■ INTERIOR

1. Front Console Box

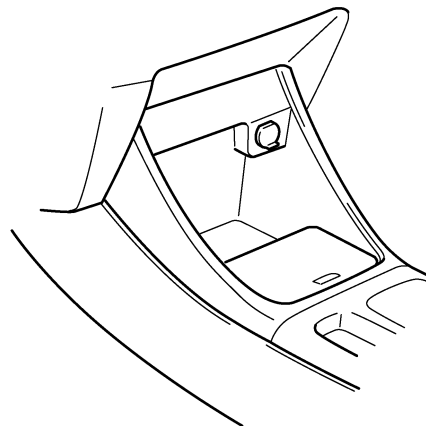
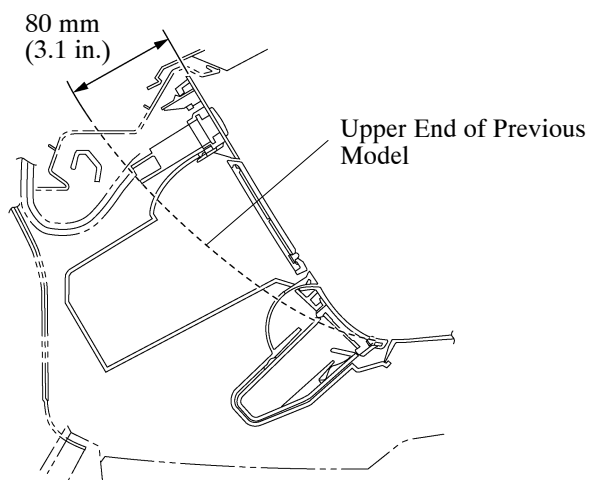
- The front console box has been changed to a type with a push-open door, thus achieving a luxurious design.
- The upper end of the console has been raised 80 mm (3.1 in.) from the previous model, thus increasing the storage capacity.
